UNITED STATES
NUCLEAR REGULATORY COMMISSION
WASHINGTON, D. C. 20555

APPLICANT: Public Service Electric & Gas Company (PSE&G)
FACILITY: Hope Creek Generating Station
SUBJECT: SUMMARY OF STRUCTURAL AND GEOTECHNICAL ENGINEERING
BRANCH (SGEB) MEETING

On August 1, 1984, a meeting was held in the Bethesda, Maryland offices of the NRC to discuss the remaining SGEB-Structural audit open items identified in the Draft SER. A list of meeting attendees is included as Enclosure 1 to this meeting summary.

FIGURE A-13-35
 RESPONSE SPECTRA COMPARISON,
 MILITARY BUILDING AT F.F.V. 54'-0".

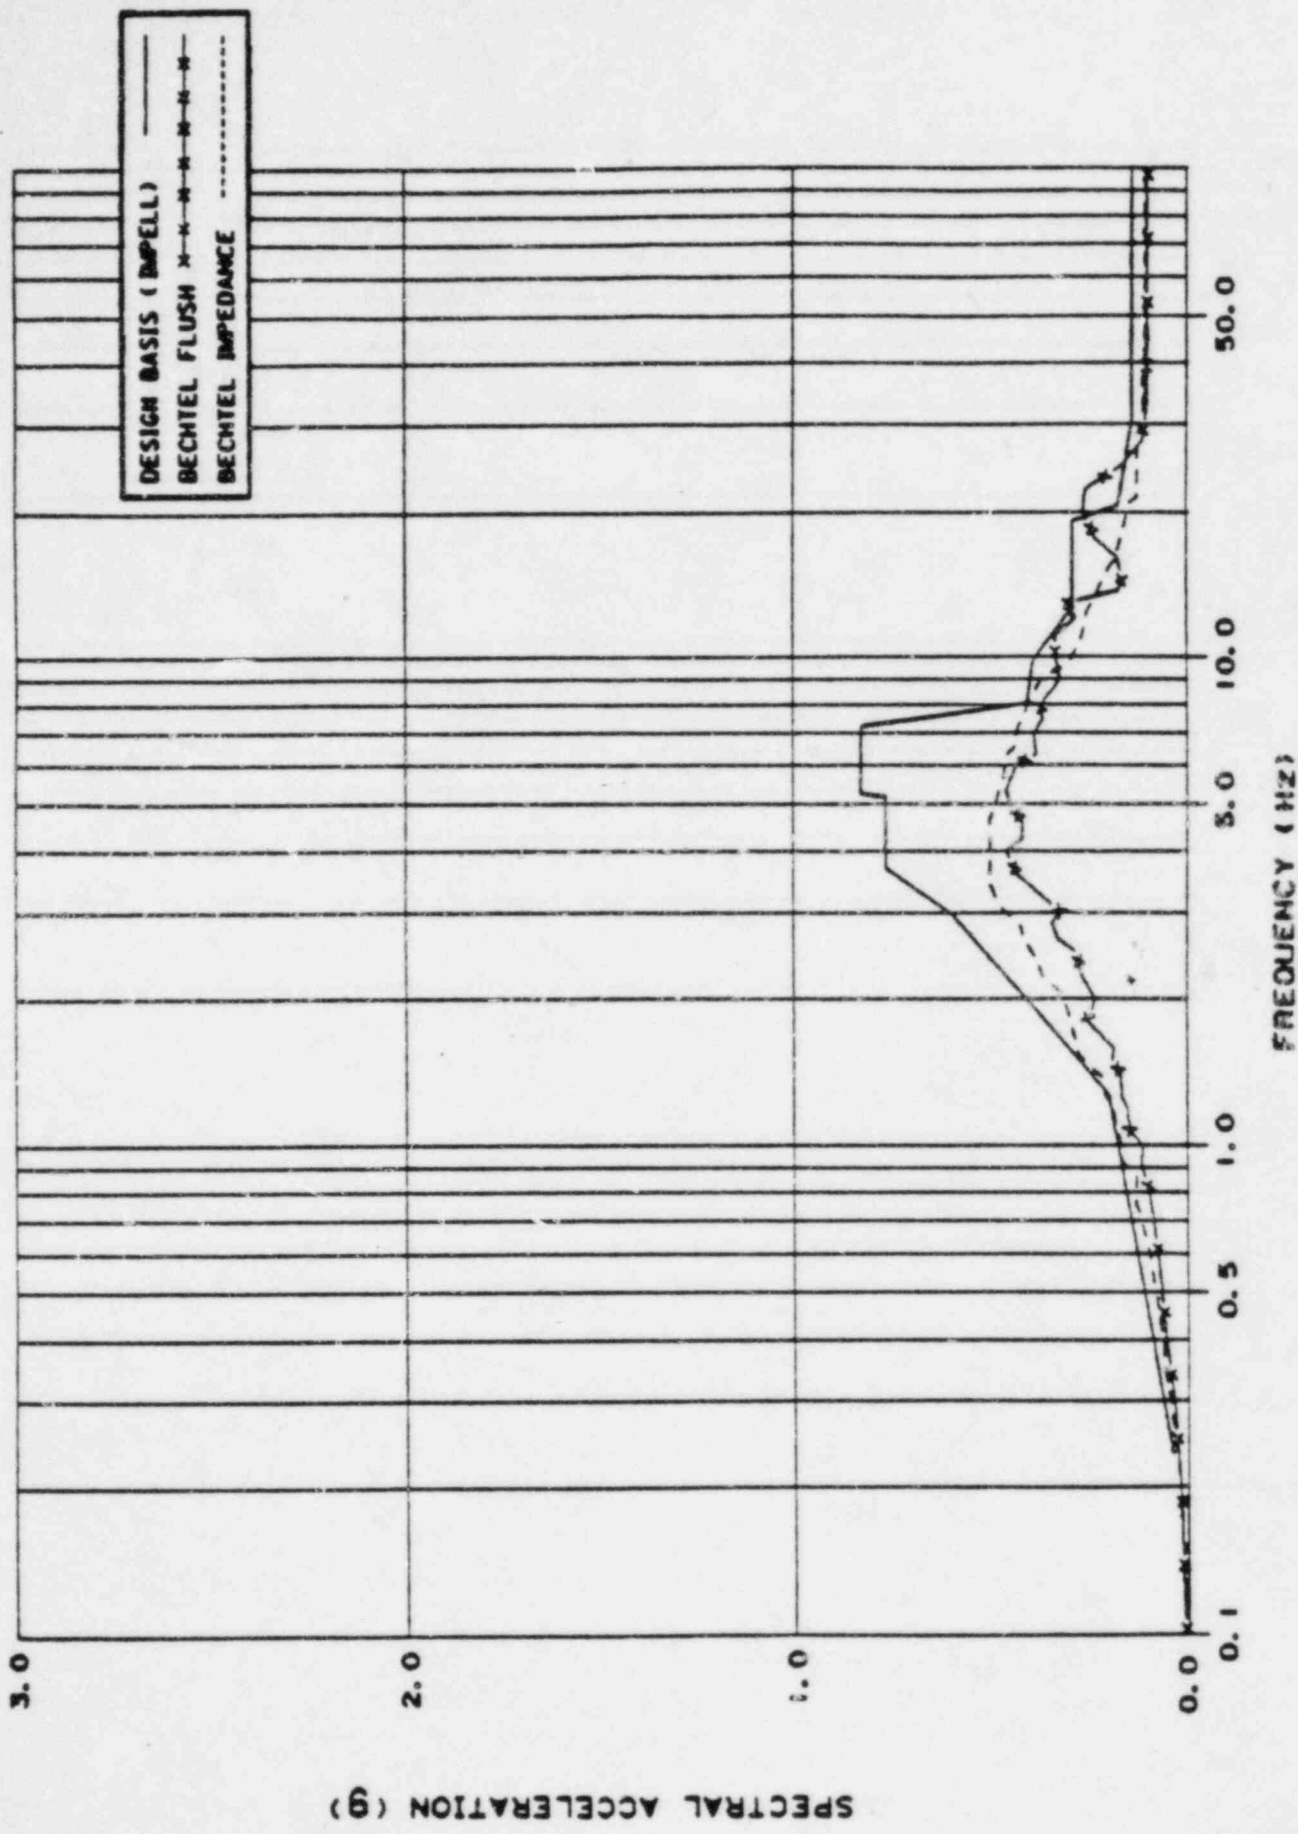
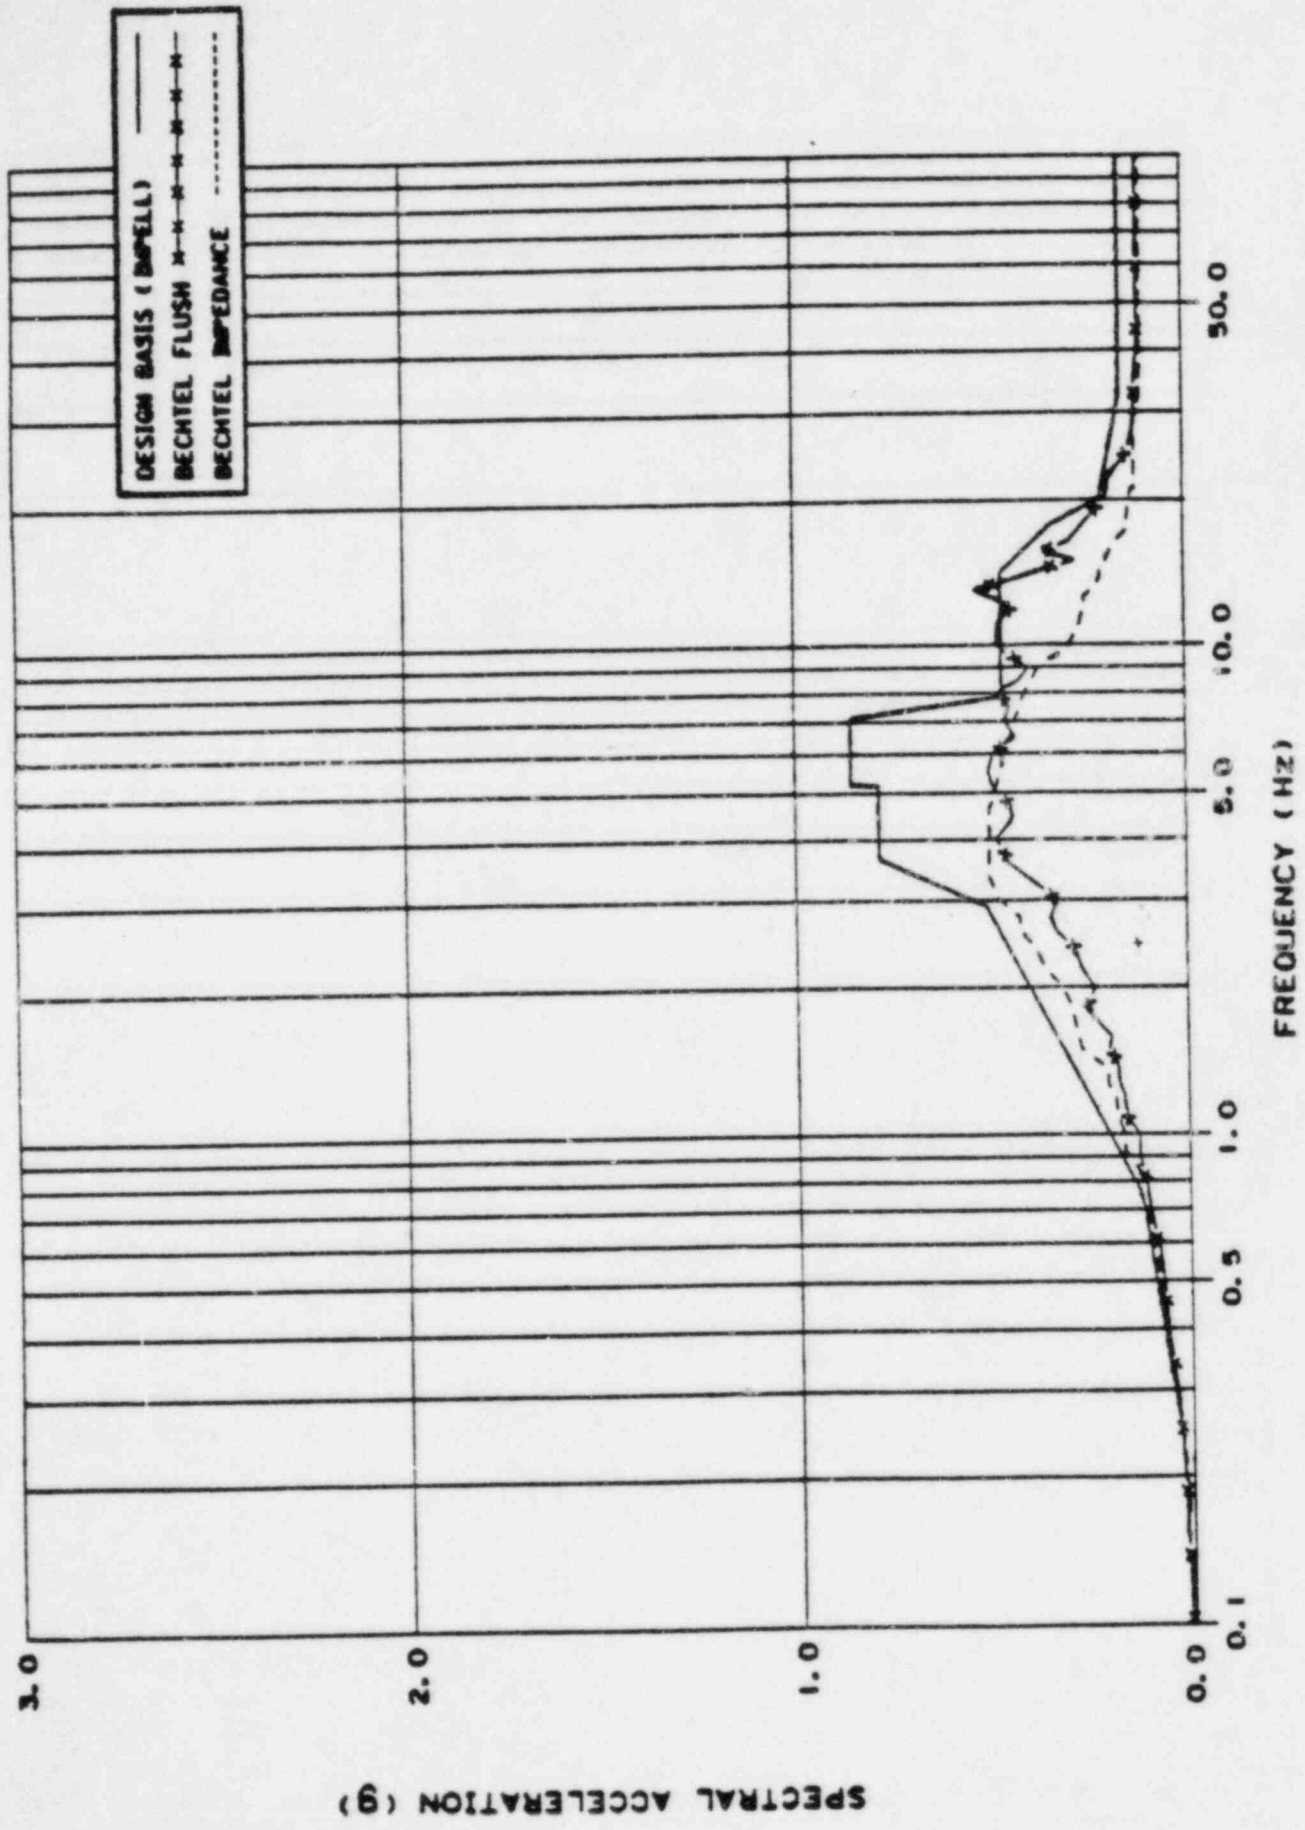
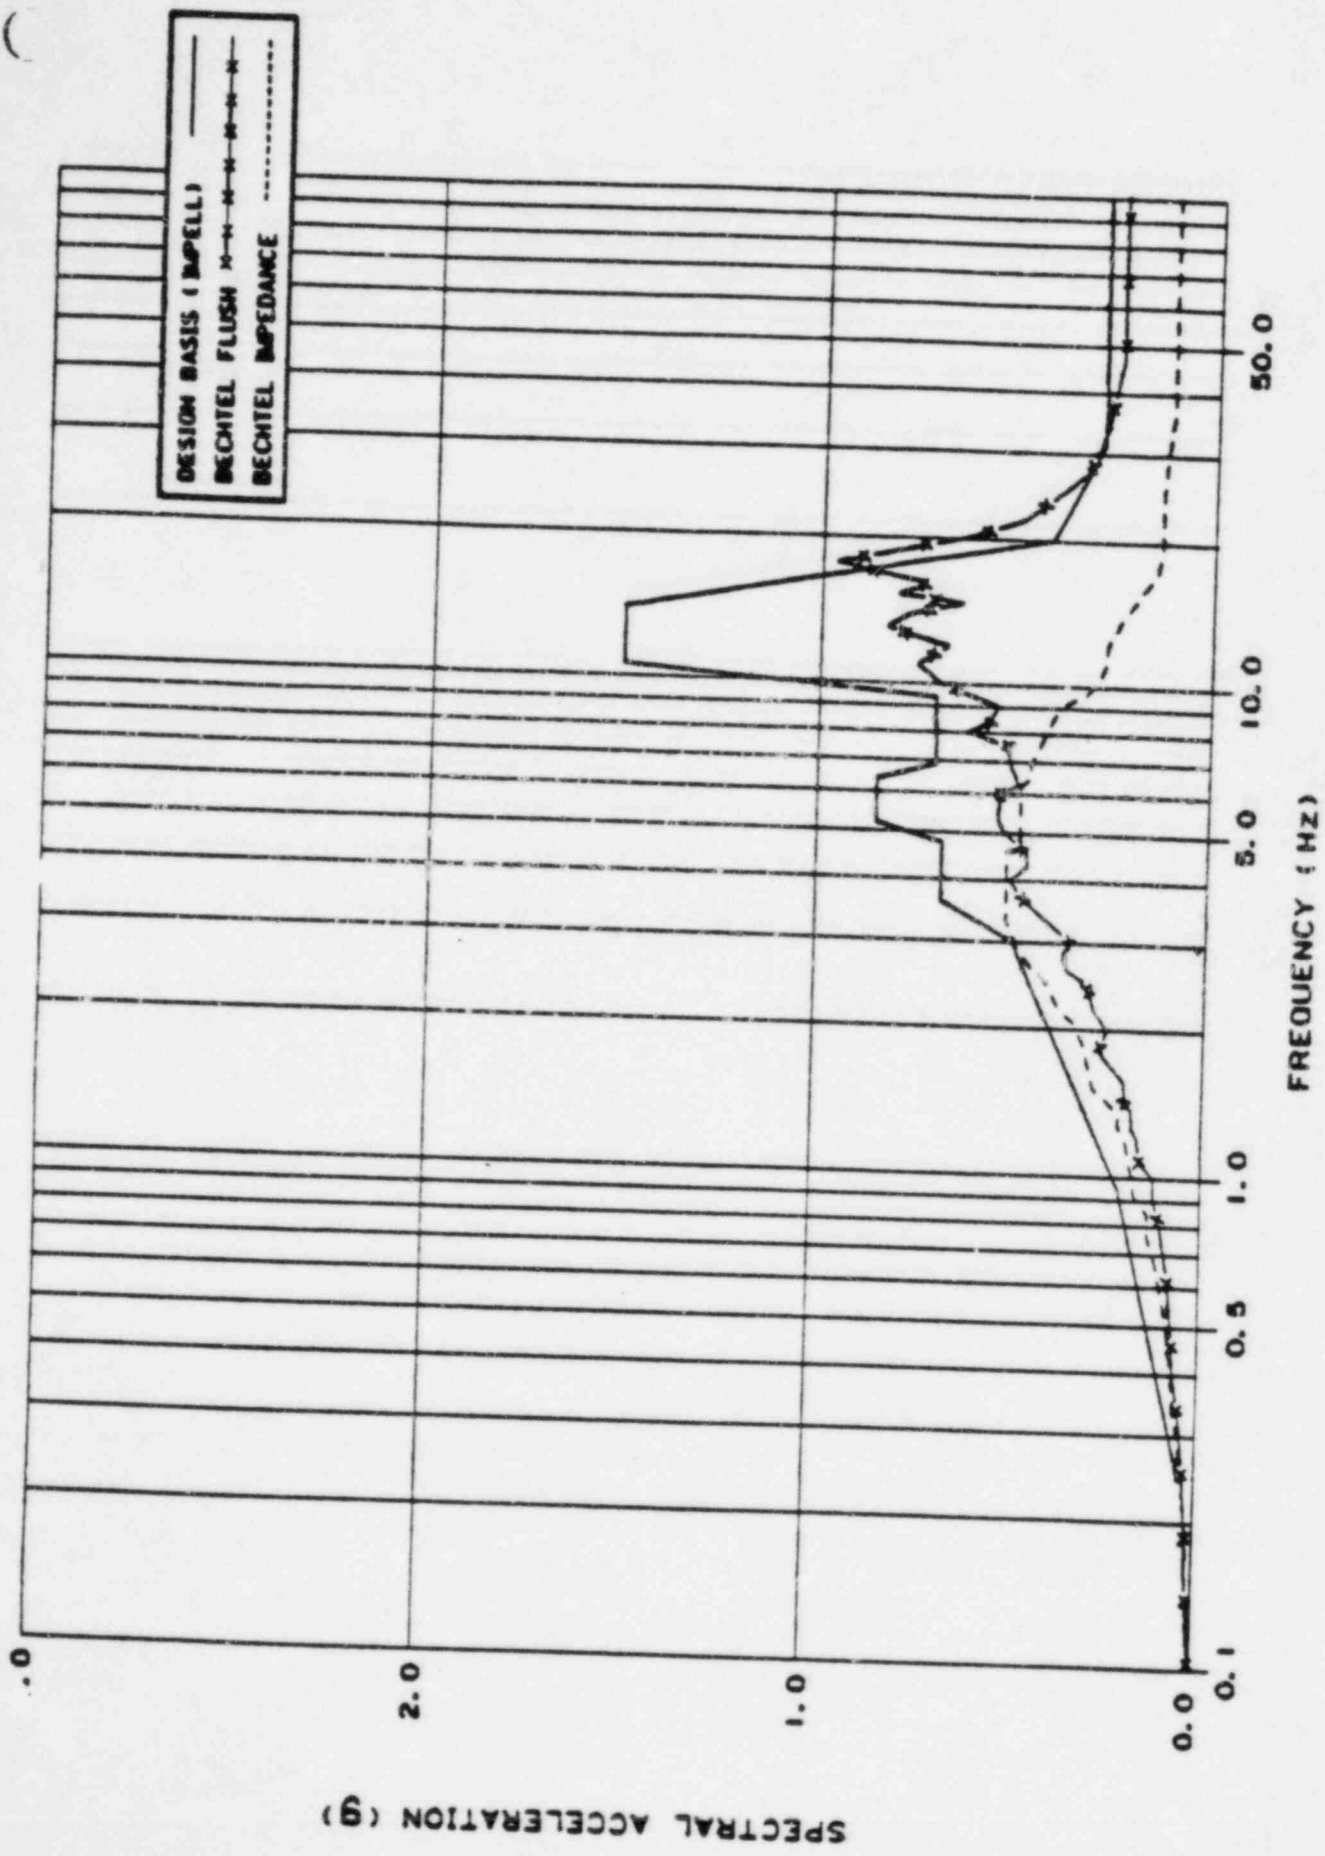
Question: Provide comparison of Bechtel Independent Verification Results with the Design Basis Results.

Figures A-13-2 to A-13-37 show the comparison of the response spectra (2% damping) obtained from the above three seismic soil-structure interaction analyses. Discussions of these comparisons are as follows:

Bechtel's independent soil-structure interaction analyses are performed using the computer code FLUSH. The results of independent finite element analyses are in reasonable agreement with those of the design basis analyses. As can be seen from Figures A-13-2 through A-13-37, the horizontal response spectra obtained from the independent finite element analyses are generally enveloped by those obtained from the design basis analyses except for the frequency range lower than 2 Hz. The vertical response spectra showed some exceedances at the frequency range of 18 Hz. These exceedances are listed in Table A-13-1.

The peak spectral accelerations obtained from the impedance approach analyses are generally lower than those obtained from the design basis analyses. However, these response spectra are not completely enveloped by those obtained from the design basis analysis, especially in the frequency range between 1.0 and 3.5 Hz. Also, there are some local exceedances in the higher frequency range, as shown in Figures A-13-2 through A-13-37.

• FIGURE 4

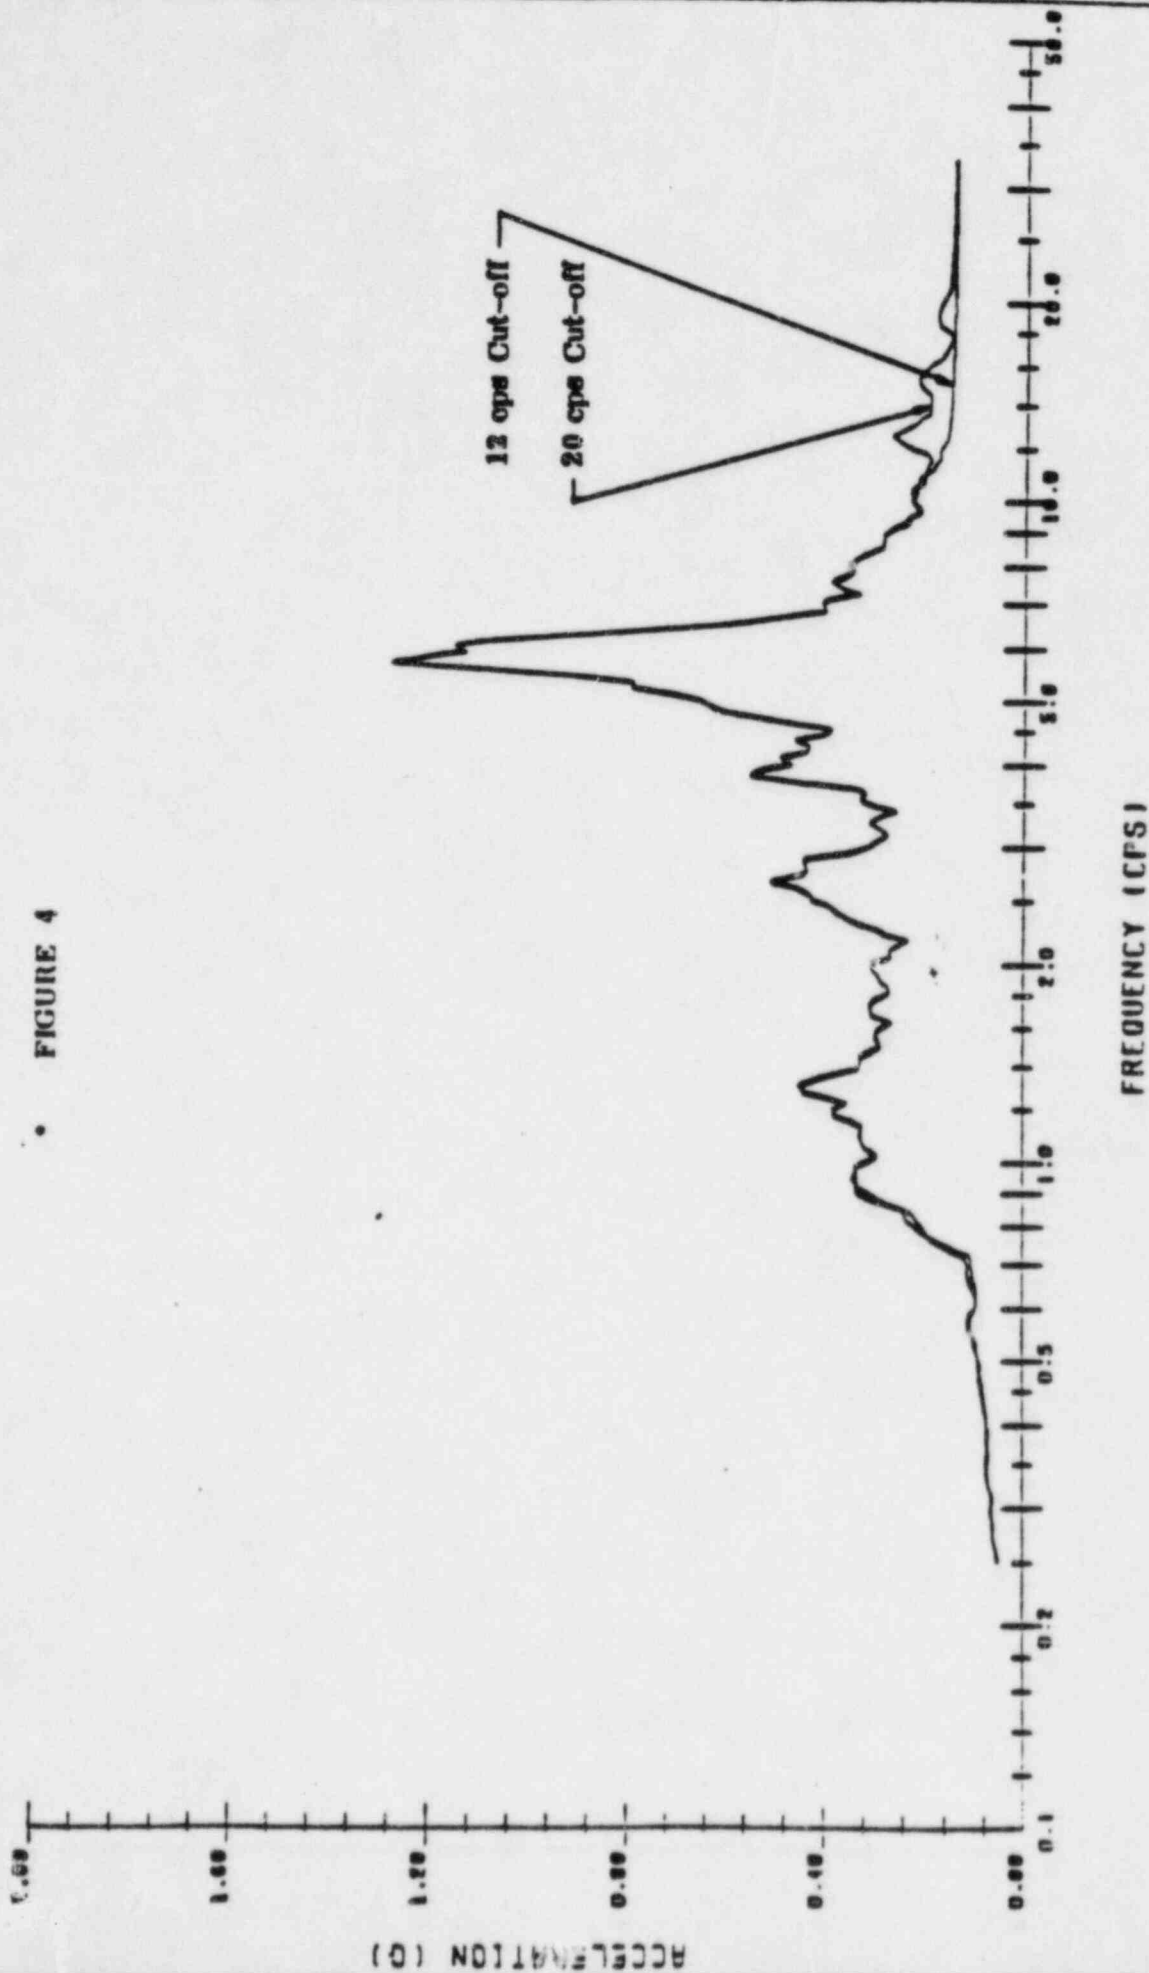
QUESTION: Justify the 12 Hz. cut-off frequency for SSI analysis.

As demonstrated by Figure 4, the base mat response for the two cut-off frequencies are essentially identified for the frequency range below 12 Hz. For the frequency range of 12 to 20 Hz., however, the response at the base mat does diverge somewhat between the two cut-off frequencies. The 20 Hz. cut-off response exhibits a number of minor peaks, as a result of high frequency components of the bedrock motion. The effect of these minor peaks on structural response is insignificant as verified by the seismic structural analysis described in the following section. The 12 Hz. cut-off analysis, on the otherhand, exhibits a non-amplified response beyond 12 Hz., resulting in a constant spectral acceleration.
